CITY OF DUPONT

PLANNING DIVISION REPORT AND RECOMMENDATION TO THE DIRECTOR

Project: Type II Site Plan Review, Type I Short Plat, and Type I Design Review – Public Works Department Decant Facility

File Number: PLNG2019-025, -031, and -035

SHEET: S4-5
OF: 11
JOB NO.: 19233.00
DWG: S4_DCF_WV

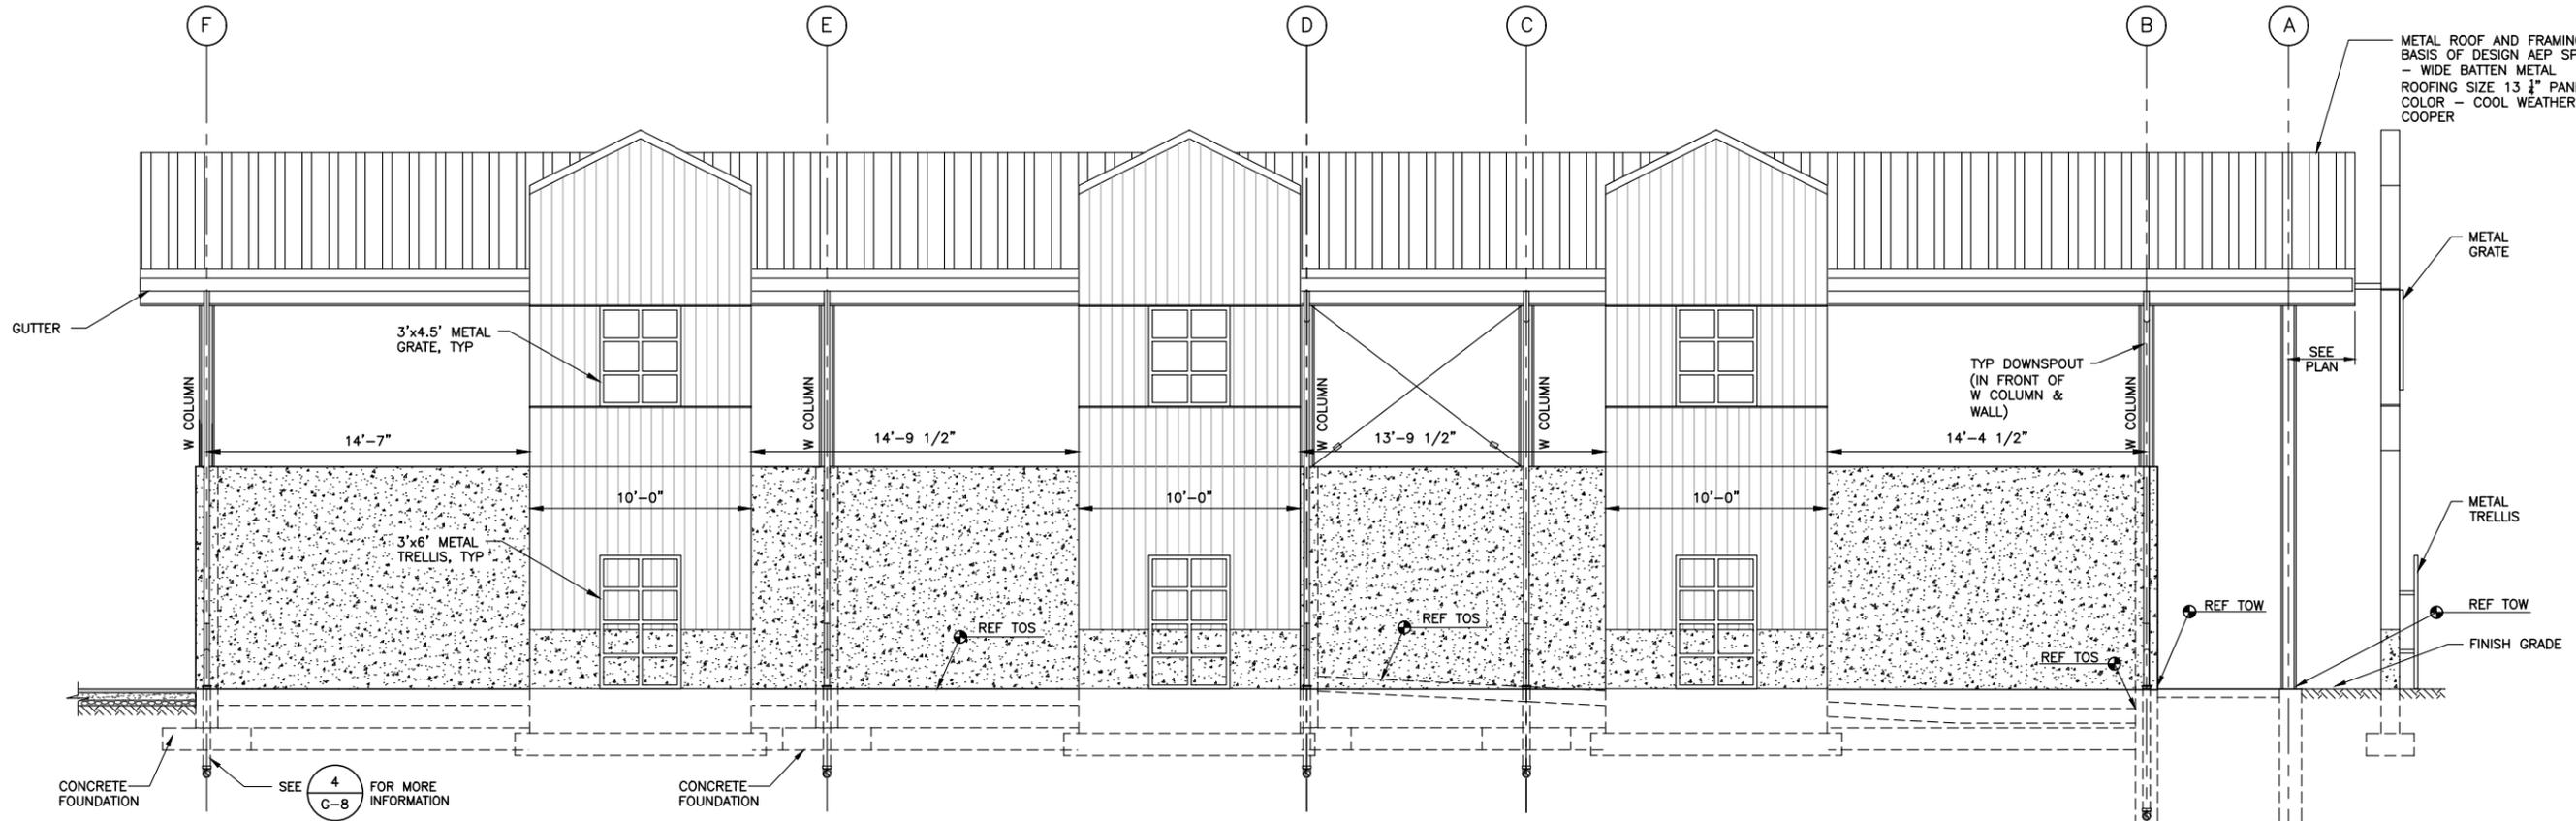
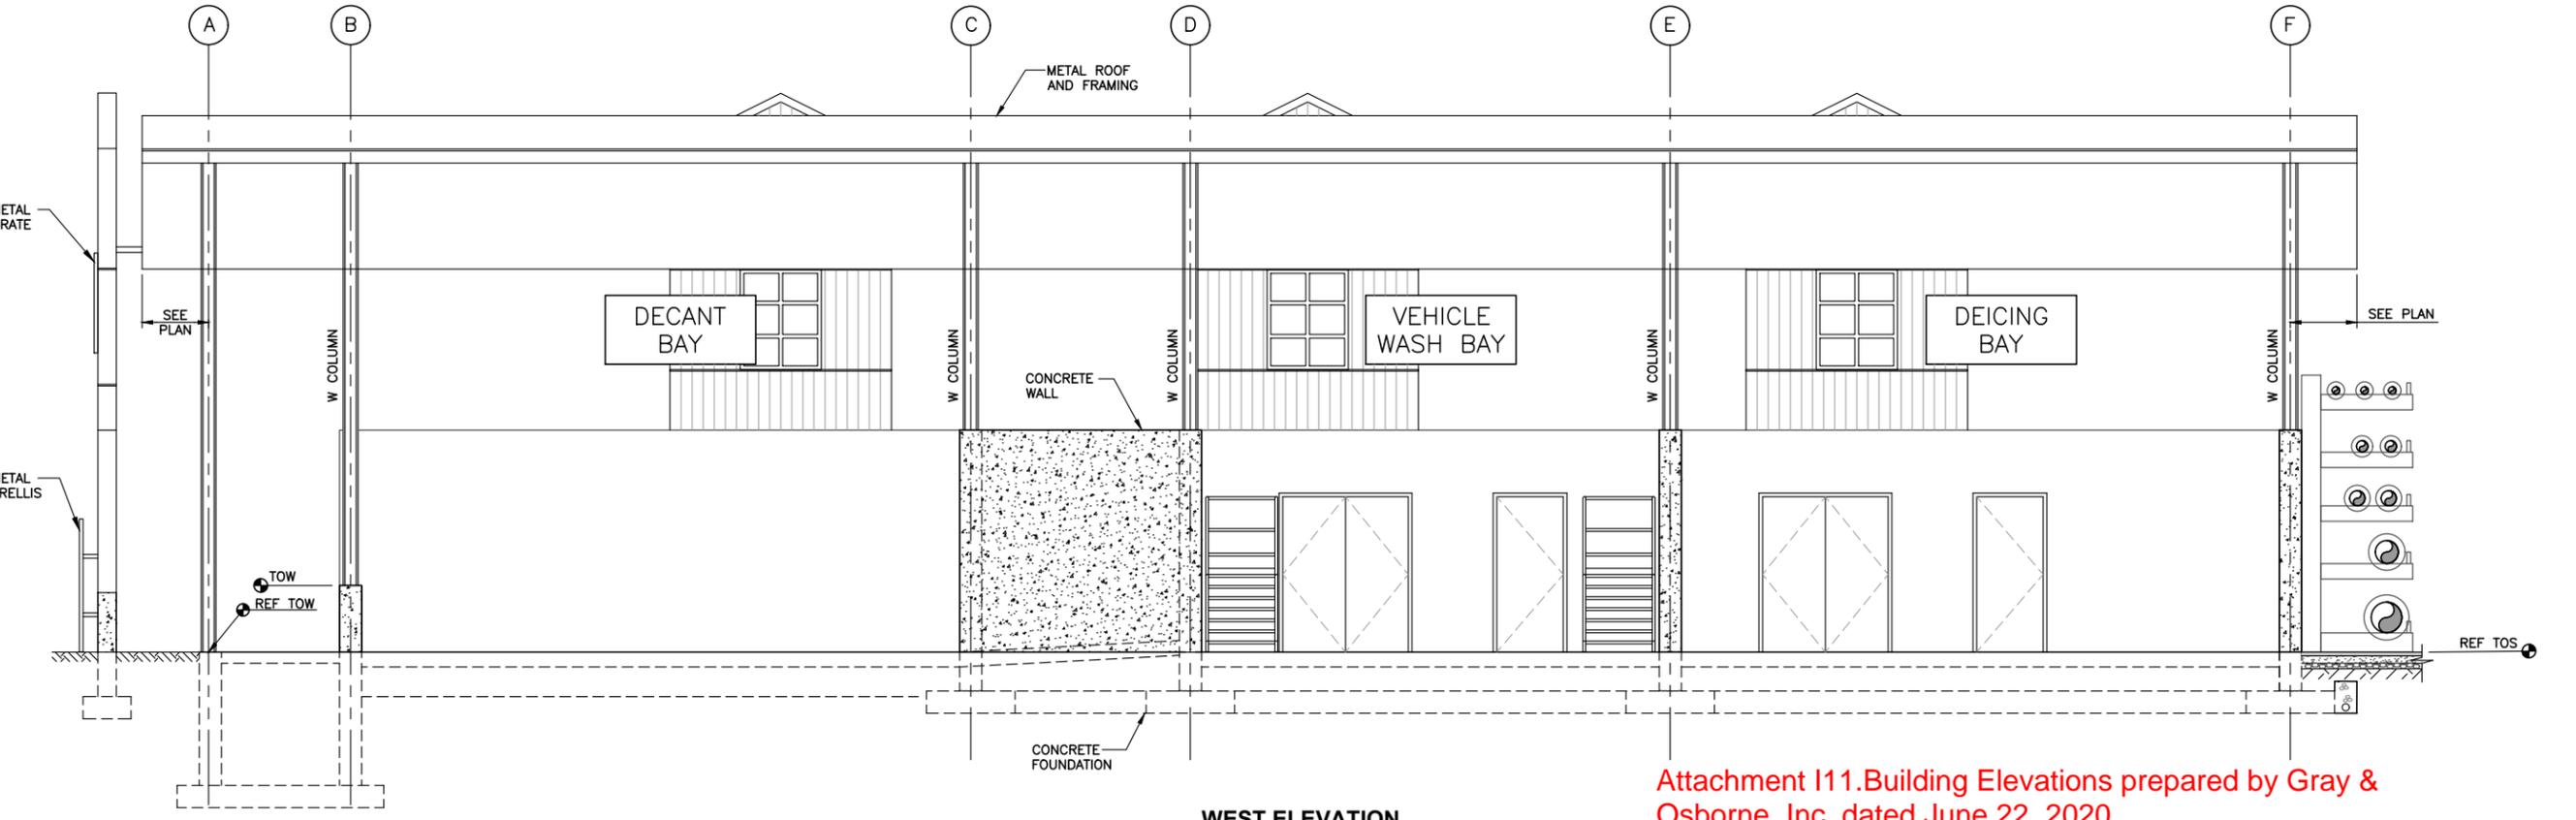
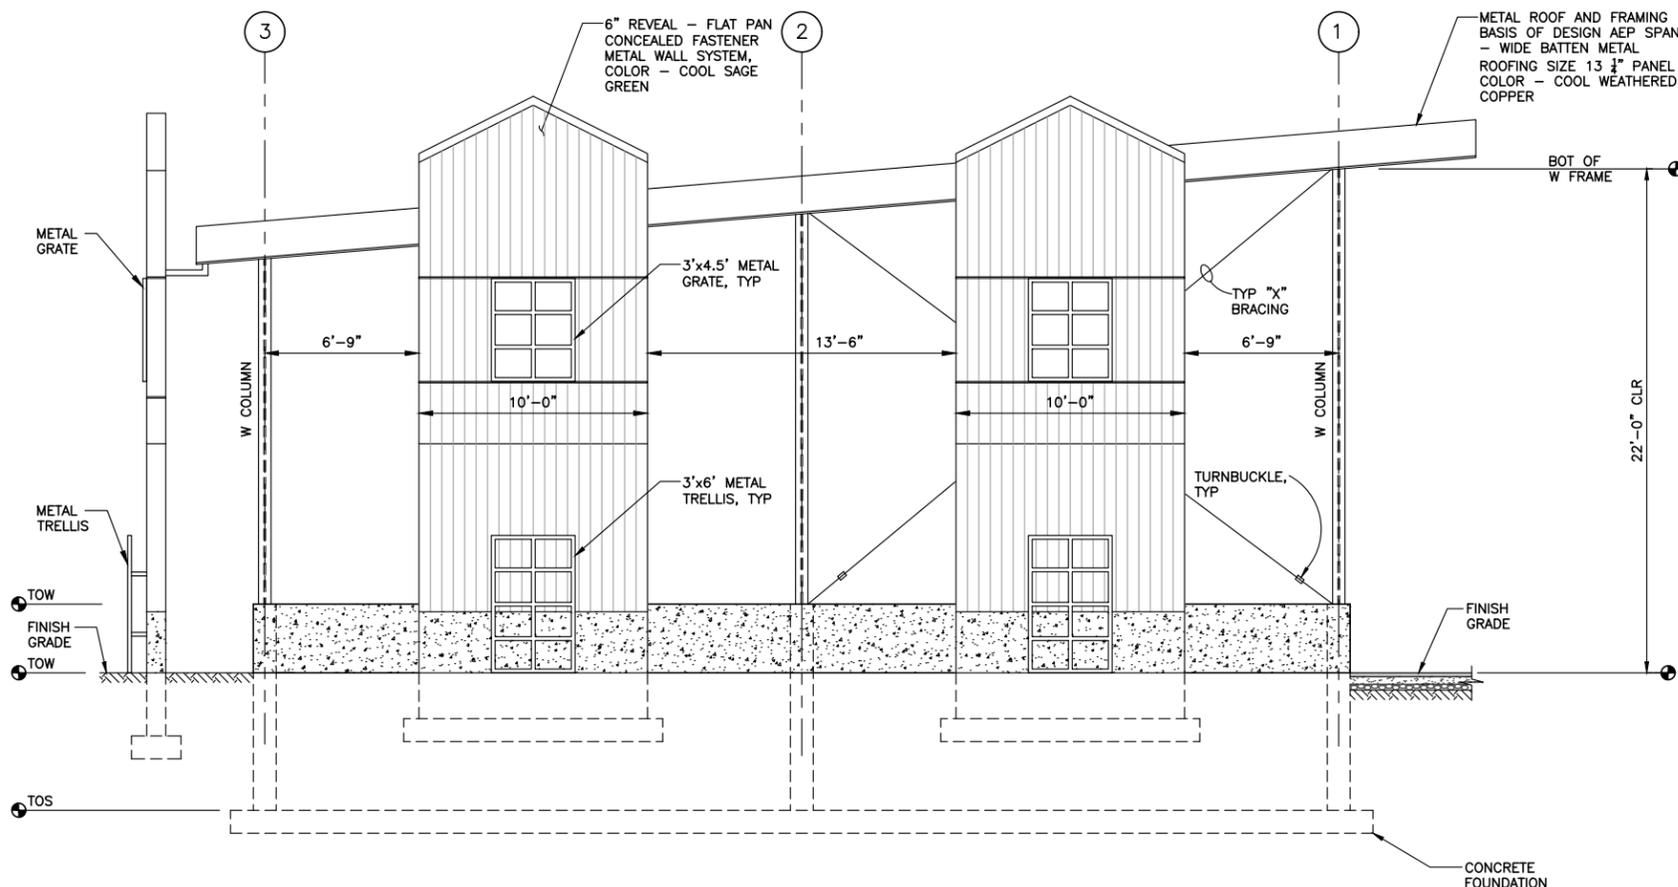
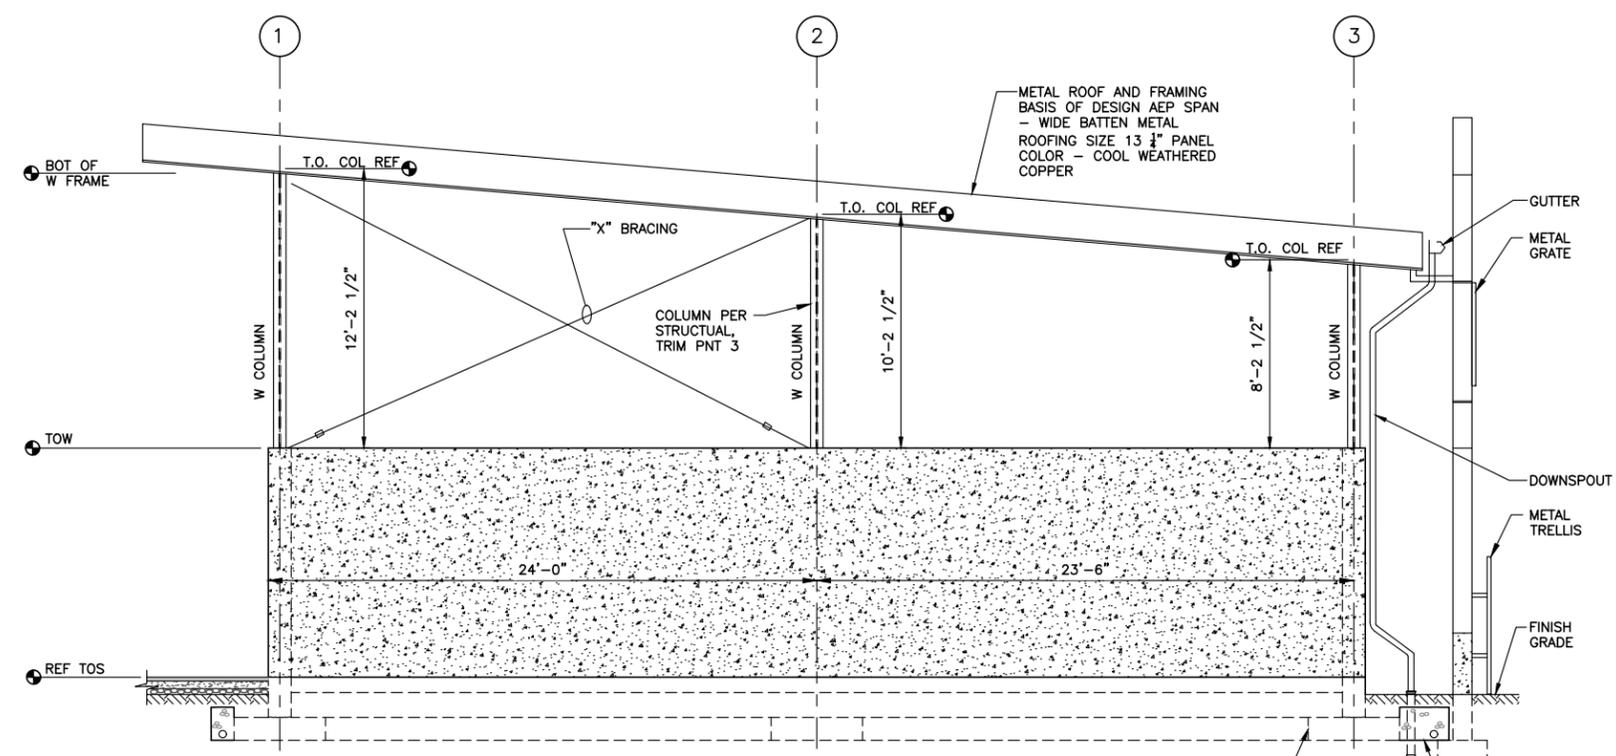
Staff Analysis and Conclusion: The proposed building metal projections will be painted “sage green” color (light green). The concrete walls are being left unpainted (grey). The accent metal grate and trellis on the metal wall projections will be painted an “iron ore” (earth tone). This iron ore colored trim is a contrasting color from the “sage green” and natural “grey” of the concrete wall. The Building Elevation Sheet S4-6 (Attachment I.11) indicates that the “iron ore” accent color is 5% of each metal wall projection. The applicant’s calculation did not include the concrete walls. If the concrete wall square footage is added to the metal wall projection square footage, the “iron ore” accent color percentage would be less than 5% of any public facing building façade.

The proposed building elements are depicted on the revised building elevations (Sheets S4-5 and S4-6). The gable projections allow for building modulation of building elements. Each projection includes multiple building elements, including an upper metal grate over an opening to replicate a multi-paned window and a lower decorative metal trellis with no glazing to also replicate a multi-paned window; fulfilling items (ii) (vi) and (vii) on the list of building elements under DMC 25.70.070(5)(a).

The materials and color are depicted on the revised building elevations (Sheets S4-5 and S4-6). Attached is a AEP Span color chart, identifying Cool Weathered Copper for the roof and Cool Sage Green for the projections.

The accent color on each gable projection will be the upper metal grate and the lower metal trellis. The metal will be Sherwin Williams Color 7069 Iron Ore. The cladding on the projections will be AEP Span Cool Sage Green. The accent color percentage is labeled on Sheet S4-6 and is 5 percent. This coverage is less than the 10 percent maximum.

Gray & Osborne, Inc. CONSULTING ENGINEERS 1130 RAINIER AVENUE SOUTH, SUITE 300 SEATTLE, WASHINGTON 98144 (206) 284-0860		
DWN BY: R.B.	SCALE: 1"=150'	SHEET 2 OF 3
CHK'D BY: R.B.	DATE: 6/17/2020	JOB NO. 19233

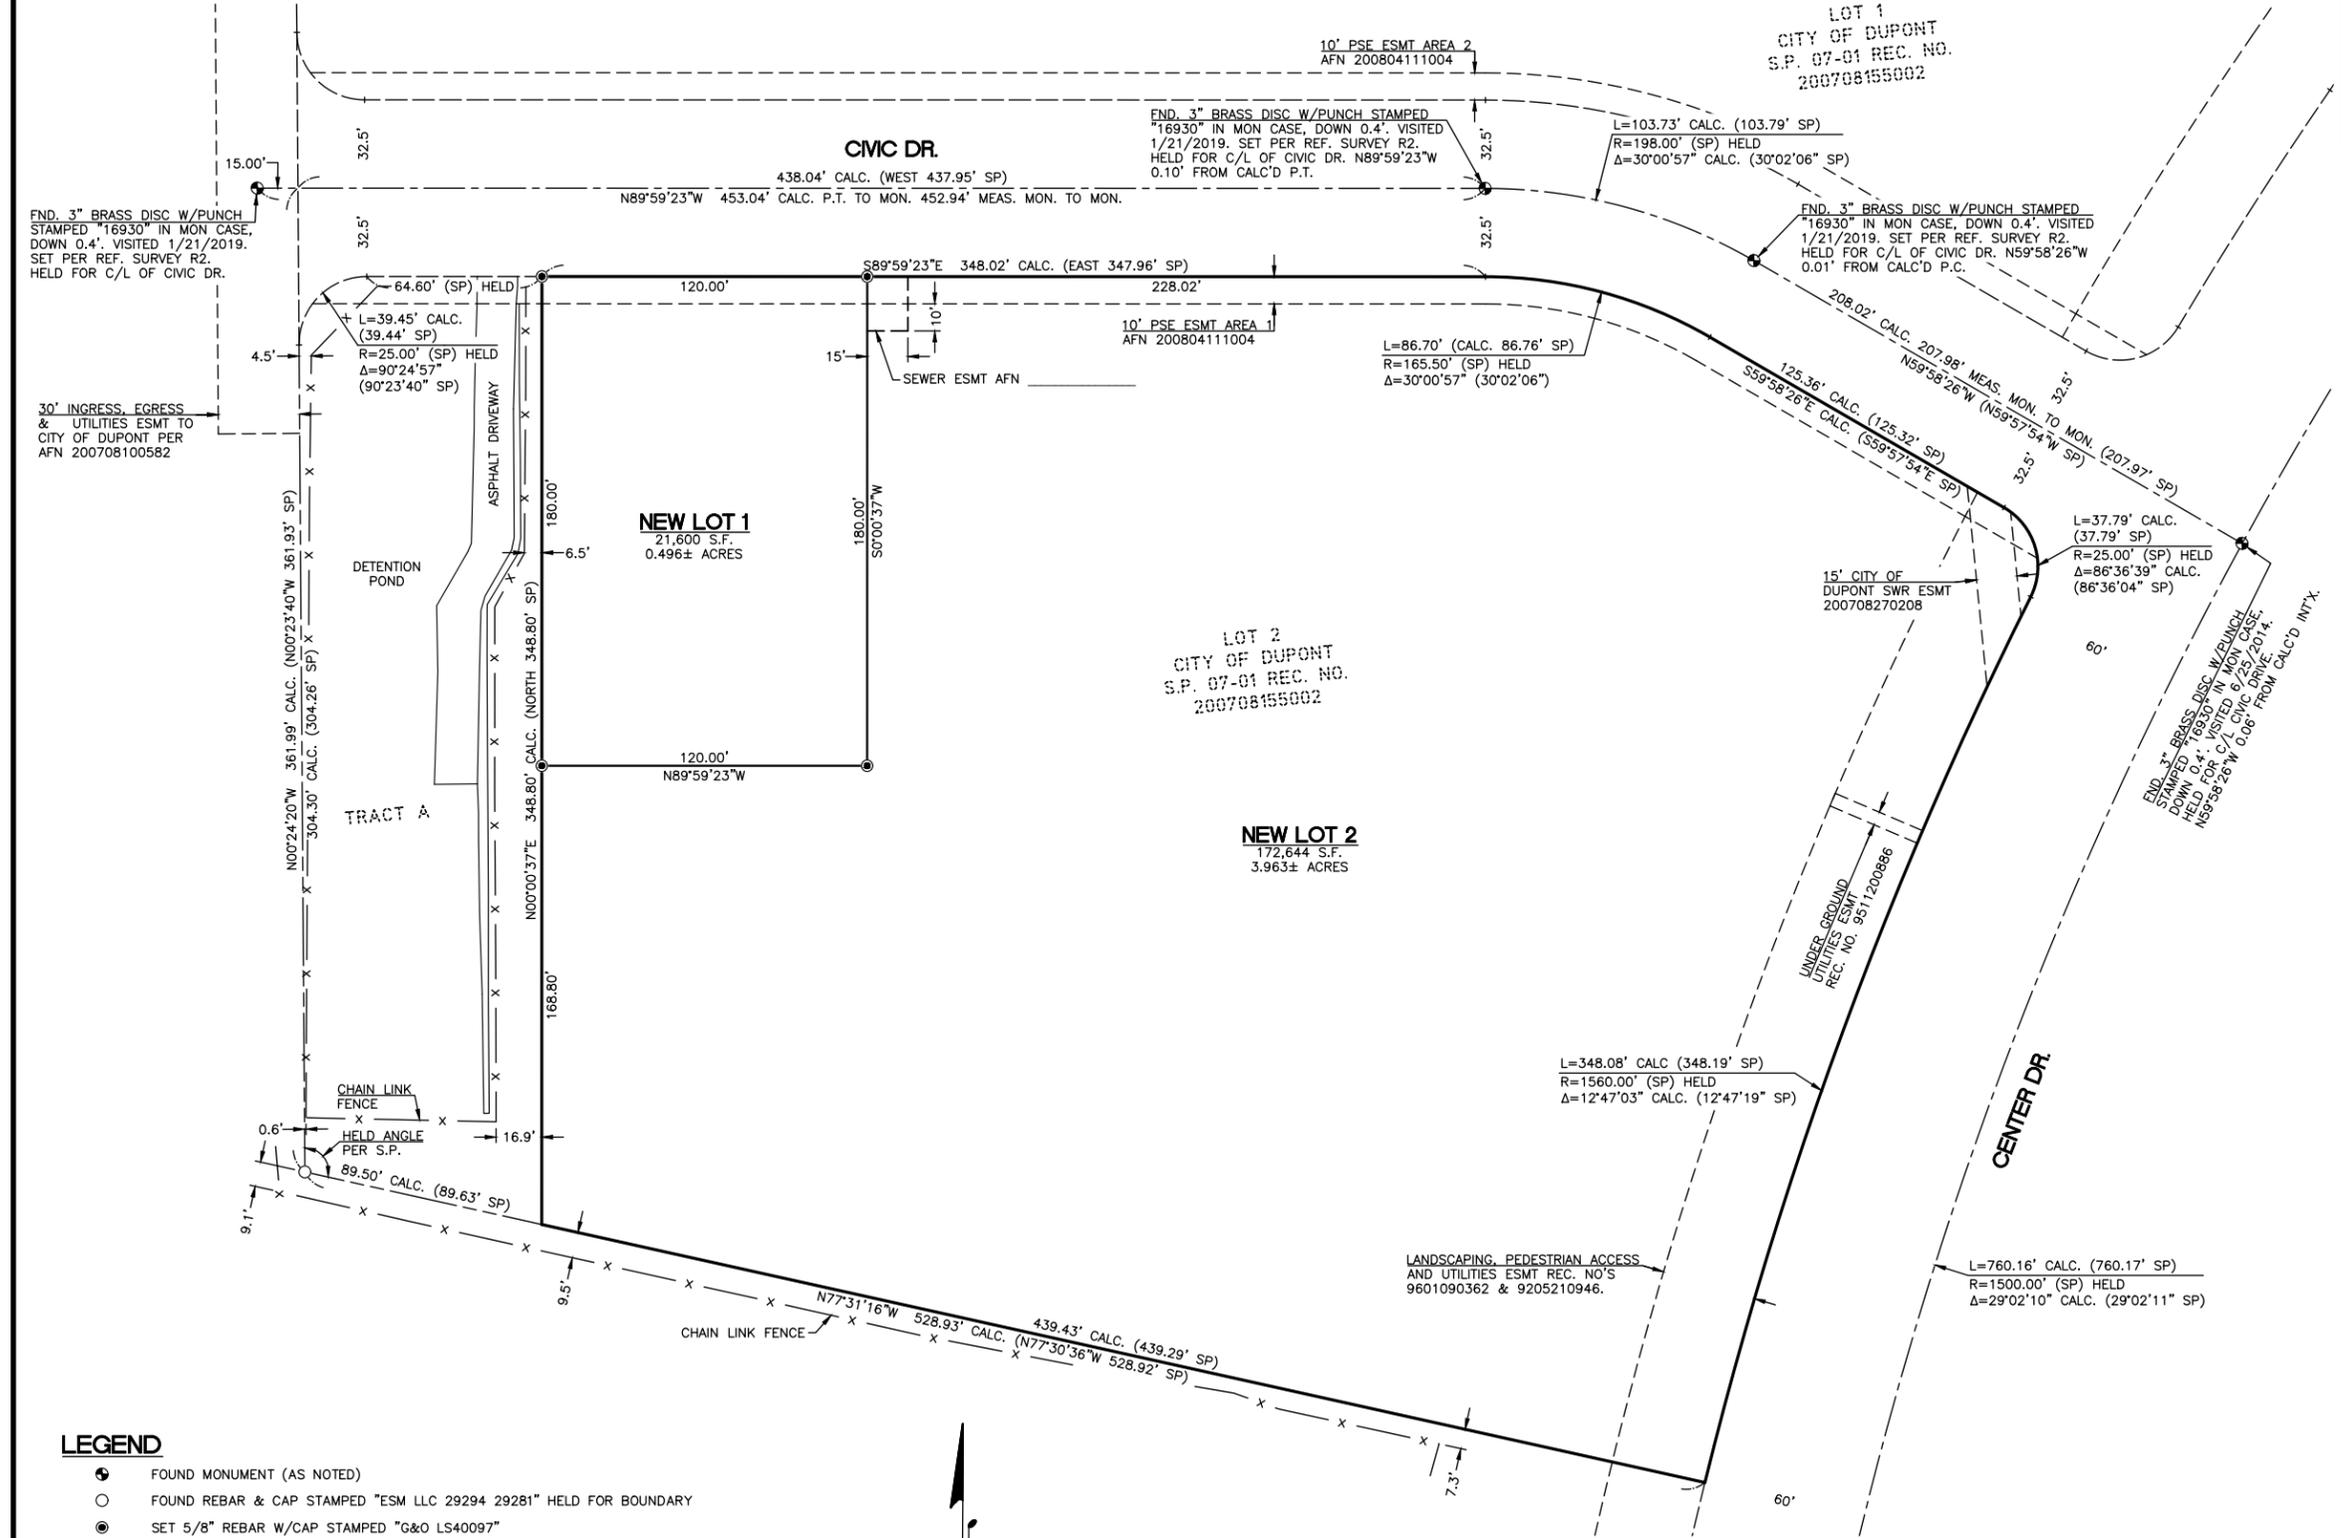
18. Complete all applicable information in Short Plat Drawings, including complete owner contact information, zoning, and sanitary sewer purveyor.
19. On Short Plat Drawing, sheet 2, include horizontal curve data for curve on Civic Drive, which is shown on sheet 3.
